Strategic Sites and Urban Renewals, Urban Assessments

Planning Assessment Report

Application to Modify Development Consent

MOD 86-7-2006 modifying DA 80-4-2004

Figure 3: Proposed Ground Floor Plan.

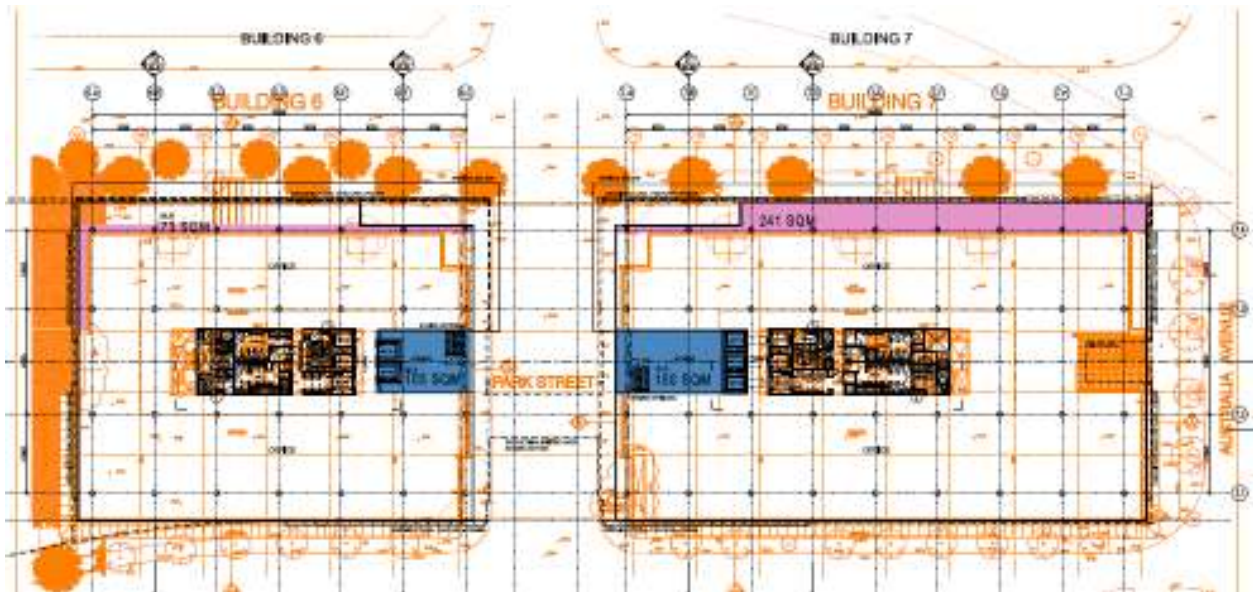
Consideration The approved plans allocated a series of retail uses along Dawn Fraser Avenue. These uses included retail, newsagency, pharmacy, café, hairdresser, a fresh food market, and a medical centre. As described in Section 1.2, approval is sought to modify the retail components. These modifications include:

Building No. 6

- Deletion of the medical centre fronting Herb Elliot Avenue and replacement with plant rooms, garbage areas, and vehicular ramps; and

- Deletion of the newsagent on the corner of Dawn Fraser Avenue and Park Street, and replacement with a Lobby area for the commercial uses at upper floor;

Building No. 7

- Additional floor area at ground floor fronting Herb Elliot Avenue for a loading dock with the associated reduction in the size of the area approved for a fresh food market;
- Deletion of the hairdresser and health food retail tenancies fronting Dawn Fraser Avenue and replacement with the Lobby area on the corner of Dawn Fraser Avenue and Park Street for the commercial uses at upper floor;
- Additional retail space fronting Dawn Fraser in the position of the approved lobby.

Amended plans were submitted by the applicant in response to this issue. Details of the amendments have been described in Section 1.3 above. These changes largely relate to the ground floor façade elements fronting Herb Elliot Avenue. The amendments provided by the applicant satisfactorily address the issue of street activation along Herb Elliot Avenue.

Figure 4: Proposed Level 1 plan illustrating increased size of floorplate (orange represents original footprint, pink represents proposed final footprint).

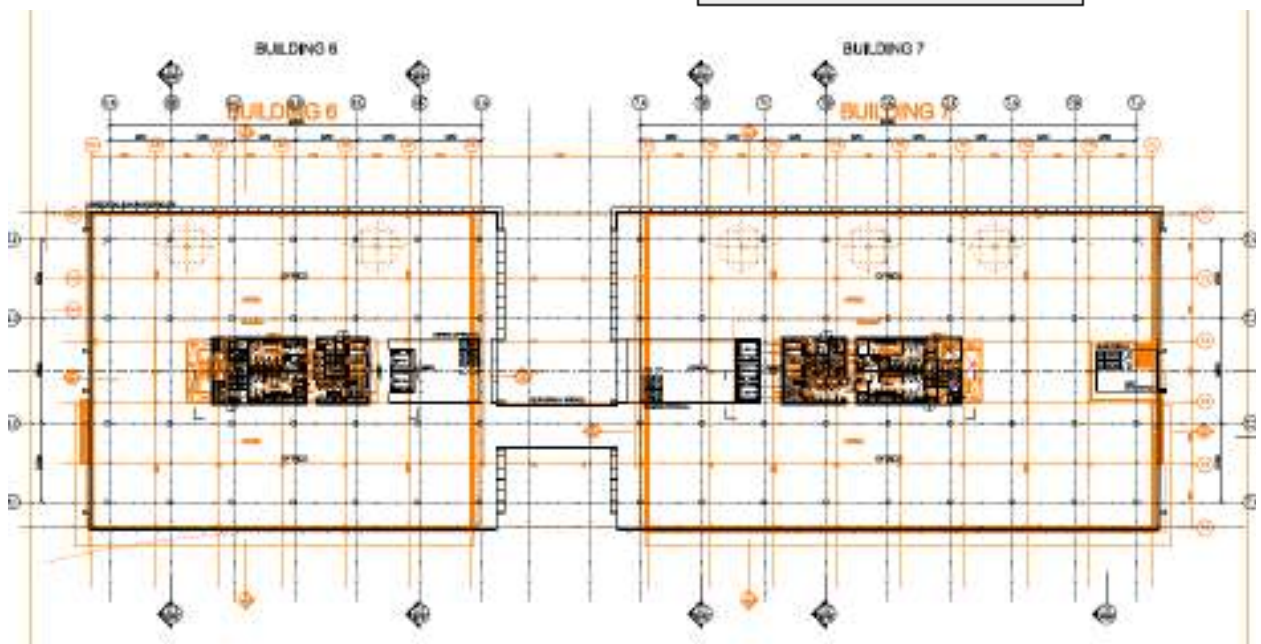
- The proposed Floor Plate overhang from Level 2 to Level 7 (ie. Level 1 to Level 6 as named in this report) adjacent to Stockroute Park creates a 'pinch point' between the Park and the building, and should be deleted.

Issue	The incorporation of a Floor Plate overhang on the north-western façade of Building 6, adjacent to Stockroute Park.
Raised by	SOPA, Urban Assessments
Consideration	The original consent allowed for a floor plate on the north-western façade of Building 6 to be incorporated from Level 2 upwards. Concern was raised by SOPA that the modified plans include a floor plate overhang on the north-western facade of Building 6, adjacent to Stockroute Park, at Level 1 creating a potential "pinch-point" for the pedestrian path between the building and Stockroute Park.

Resolution The amended plans have actually increased the setback of Building 6 from the pedestrian path at the ground floor level which increases the width available for this pathway. A minor increase in floor area is proposed to the north-western elevation of Building 6, in the north-western corner, to make it consistent with the remainder of the western elevation alignment at level 1. Elevations and sections of Building 6 and its relationship to the public pathway and Stockroute Park have confirmed that the minor increase in floor space in this section of the building, in combination with the proposed greater setback at ground level, will not result in the creation of a “pinch-point” to the pedestrian pathway. There is sufficient height and clearance between the pathway and underside of the structure to ensure that the space does not feel enclosed. SOPA is satisfied with the amended plans and no longer have an issue with this aspect of the proposal.
